Subject: Parties in Opposition Response to Applicant's 3D SketchUp Drawings - BZA  
Case No. 20382- 308 11th Street NE

Below are mark-ups of the Applicant's 3D SketchUp drawings from Exhibit 90A, which are shown side by side with the graphical overlay photos submitted by the Parties in Opposition in Exhibit 83, upon which the Applicant bases its 3D drawings.

Exhibit A: View of the garage from the alley (corresponds to Exhibit 83, Slide 15)

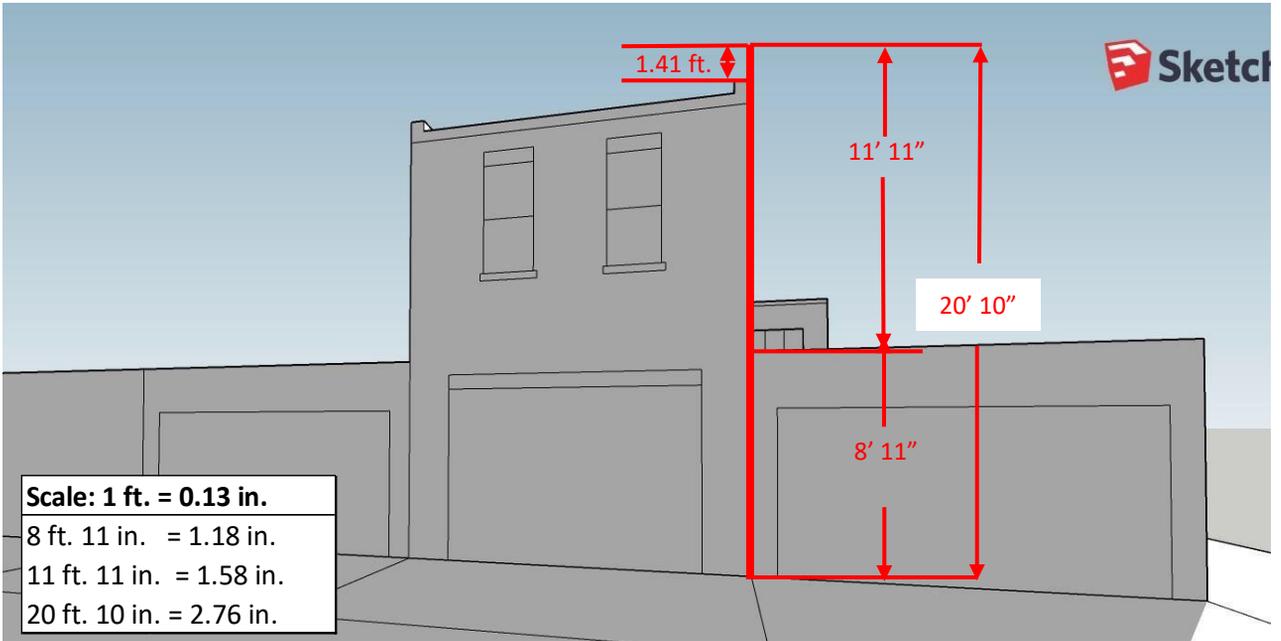
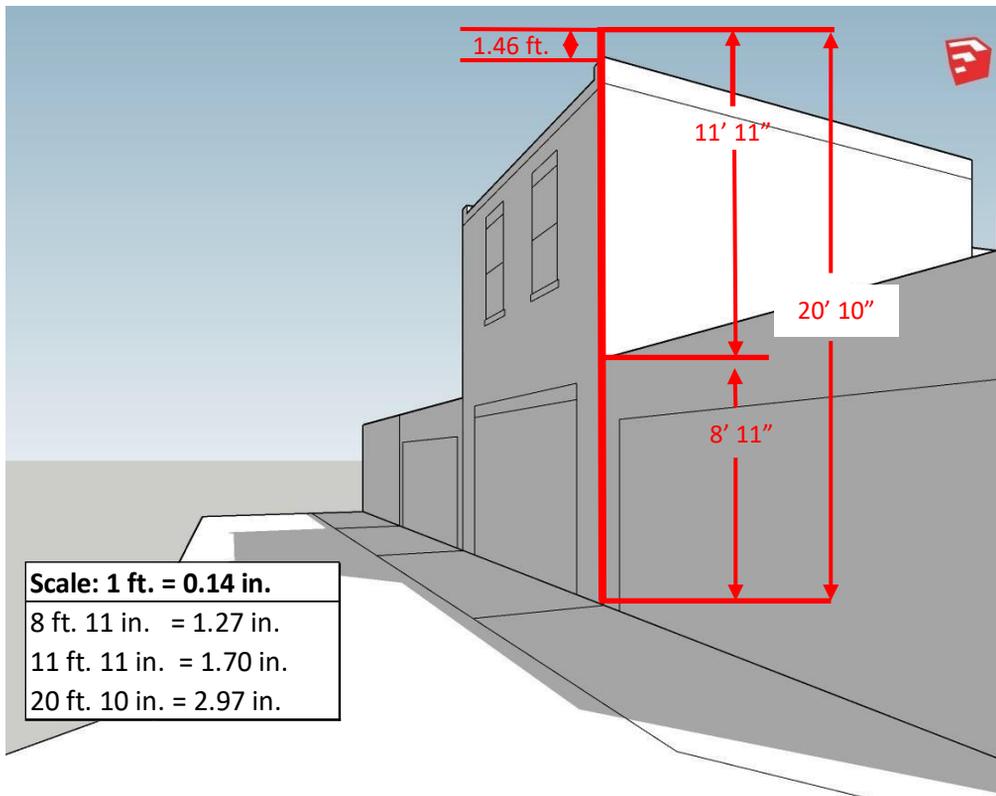
**Exhibit A and Slide 15.** Exhibit A does not include dimensions and when graphically verified, shows an inaccurate height that appears to be short by ~1.41 ft. We graphically checked the Applicant's 3D drawing for accuracy and found the height to be significantly shorter than the height proposed in the Applicant's architectural drawings in Exhibit 70. The Applicant's drawing in Exhibit A shows that the proposed structure will substantially visually intrude on the scale of the existing garages along the side of the alley, at more than 2.3 times the height of the existing and adjacent garages.

Exhibit C: View of the garage from the rear yard at 306 11<sup>th</sup> Street NE (corresponds to Exhibit 83, Slide 22)

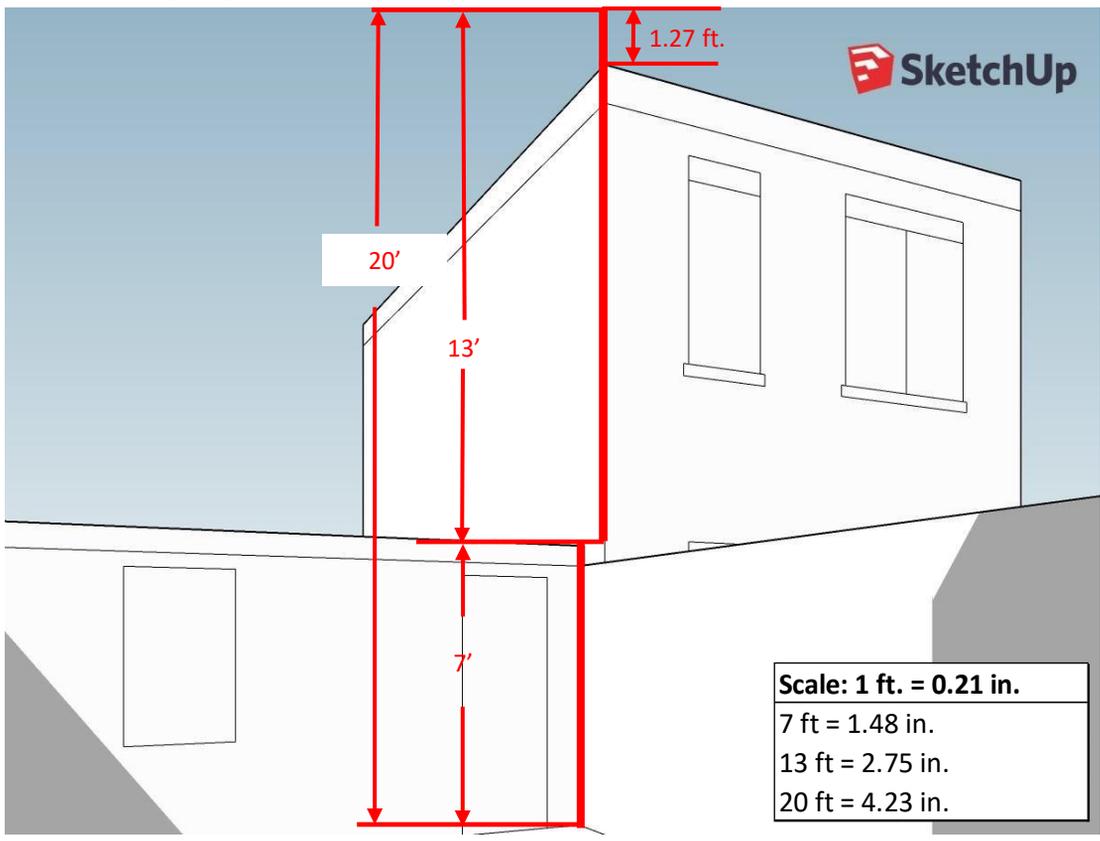
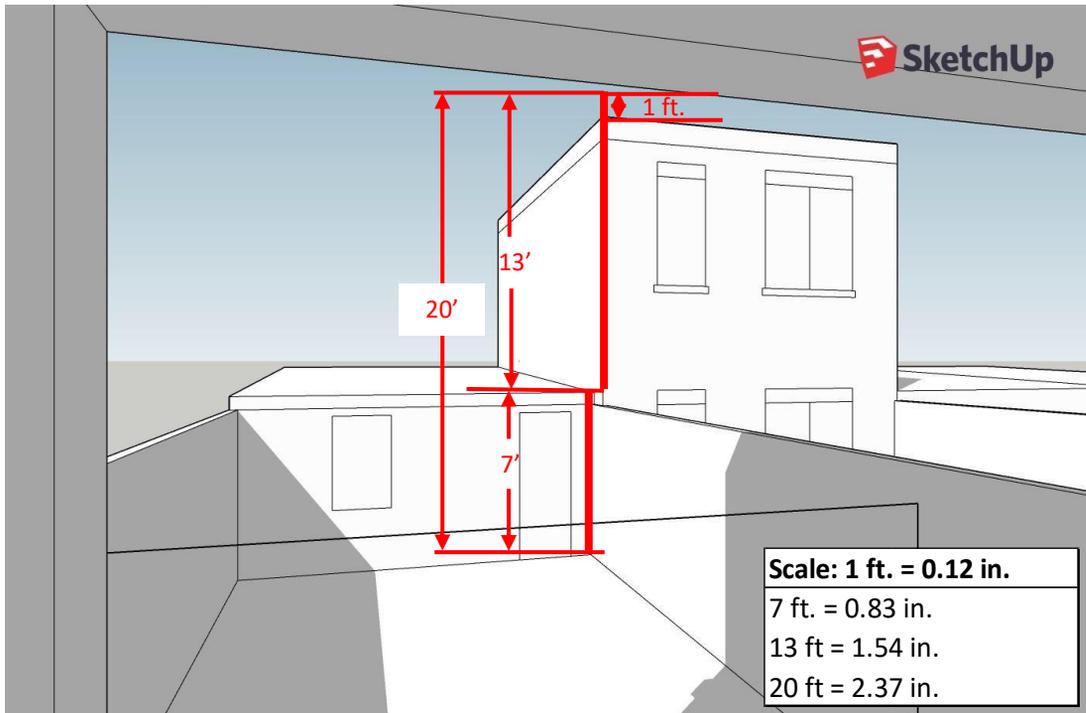
**Exhibit C and Slide 22.** Exhibit C does not include dimensions and when graphically verified, shows an inaccurate height that appears to be short by ~1.27 ft. The Applicant incorrectly states that the photograph was taken at barely above ground level. As seen in the photograph, in order to capture the 20 ft. height of the proposed 2-level garage, the photograph was taken about 3 ft. off the ground, standing as far back from the proposed garage as possible (approximately 18 ft.). Even at this location, it was difficult to capture the proposed 20 ft. height. To get the perspective in Exhibit C, the Applicant uses a wide-angled field of view to create a view not possible as the human eye sees, making the adjacent rear yard appear larger and minimizing the perspective of the proposed garage height. The Applicant is correct that the graphic in the photograph retains the larger footprint, approximately 1 ft. longer than currently proposed. Even so, the minor reduction in length does not mitigate the proposed 2-level garage's unprecedented height and volume in comparison with the adjacent and

surrounding garages.

**Exhibit D:** View of the garage from the first-floor interior of 306 11<sup>th</sup> Street NE (corresponds to Exhibit 83, Slide 24)

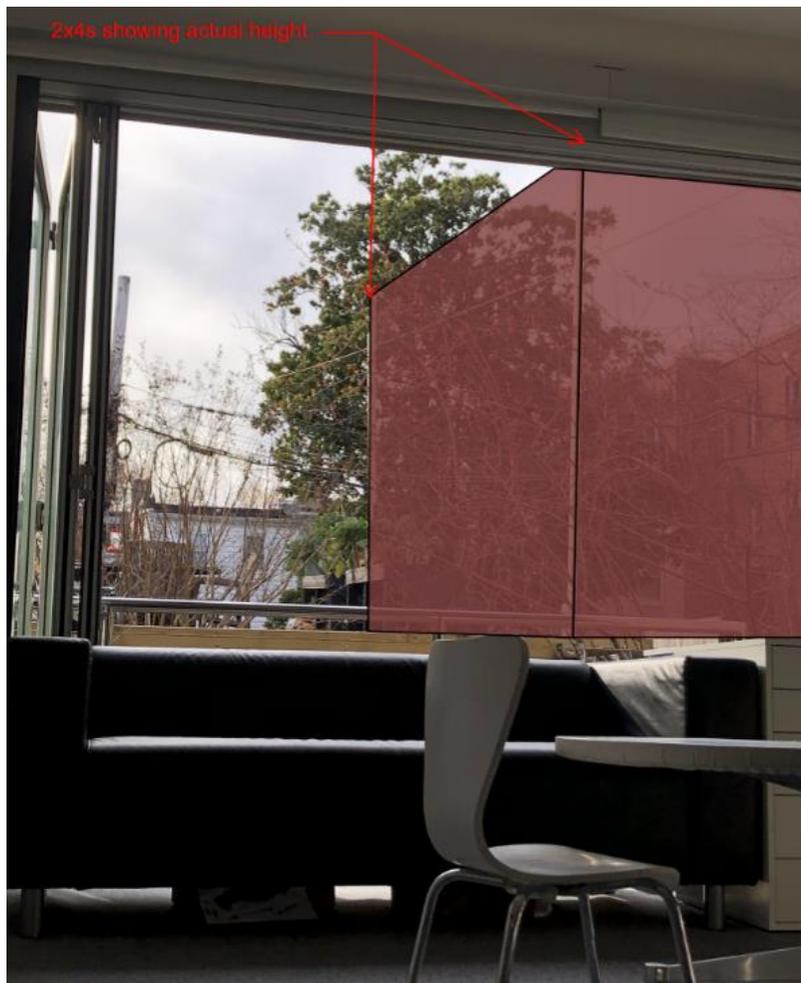
**Exhibit D and Slide 24.** Exhibit D does not include dimensions and when graphically verified, shows an inaccurate height that appears to be short by ~1 ft. The Applicant's 3D wide-angled perspective in Exhibit D depicts a view that is not physically possible from the adjacent property given the existing sidewall, deck, and width of the doors (9 ft.). To create this view, the Applicant uses a different location than in the photo, uses a very wide field of view, and omits existing physical structures. When compared to the actual photograph of the same view, the Applicant's 3D graphic results in the illusion of an unobstructed view, exaggerates the length and width of the adjacent property, and minimizes the height of proposed 2-level garage.

**Exhibit E:** View of the garage from the second-floor balcony of 306 11<sup>th</sup> Street NE (corresponds to Exhibit 83, Slide 26)

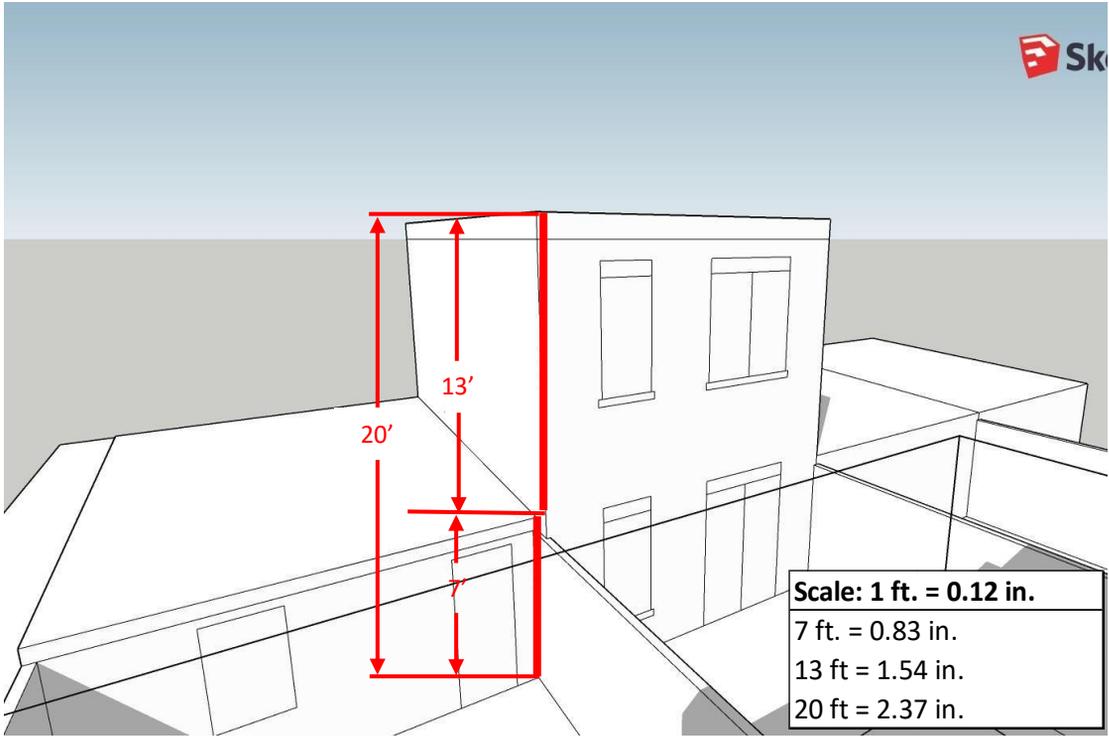
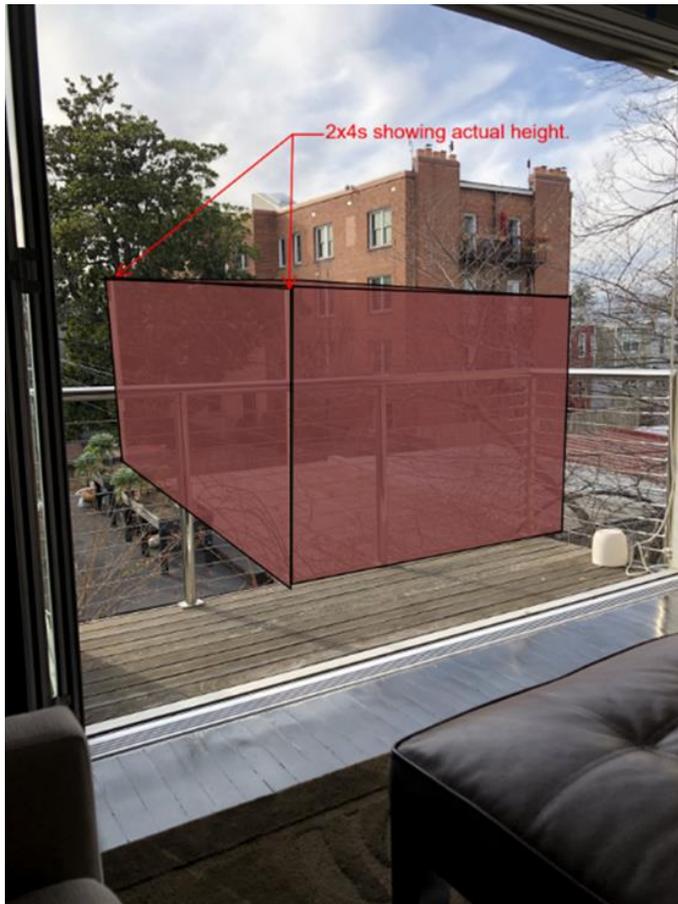
**Exhibit E and Slide 26.** Exhibit E does not include dimensions. The Applicant's 3D wide-angled perspective in Exhibit E (the view from the interior second floor of the south adjacent property) is physically impossible to view as the human eye sees when in the adjacent property. The Applicant's drawing makes it appear as if the viewer is floating in the air above the properties rather than inside the adjacent property as illustrated in the adjacent photograph. The Applicant has also removed existing physical structures (including the main building), giving the illusion of unobstructed views and eliminating the proposed 2-level garage's negative impact on light and air.

**Exhibit F:** View of the garage from the second-floor balcony of 310 11<sup>th</sup> Street NE (corresponds to Exhibit 83, Slide 27)

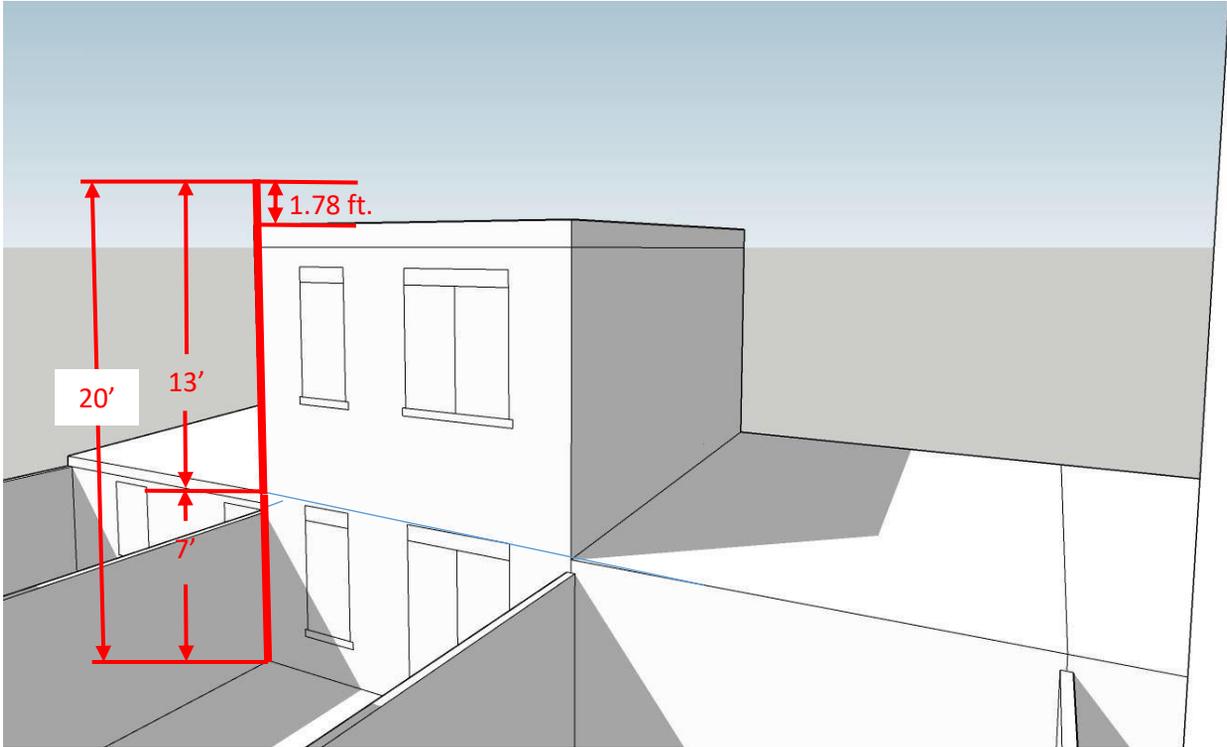
**Exhibit F and Slide 27.** Exhibit F does not include dimensions and when graphically verified, the height is short by ~1.78 ft. As with all the other 3D graphics, the use of the wide-angled perspective makes the proposed 2-level garage look farther away than it would if viewed as the human eye sees.
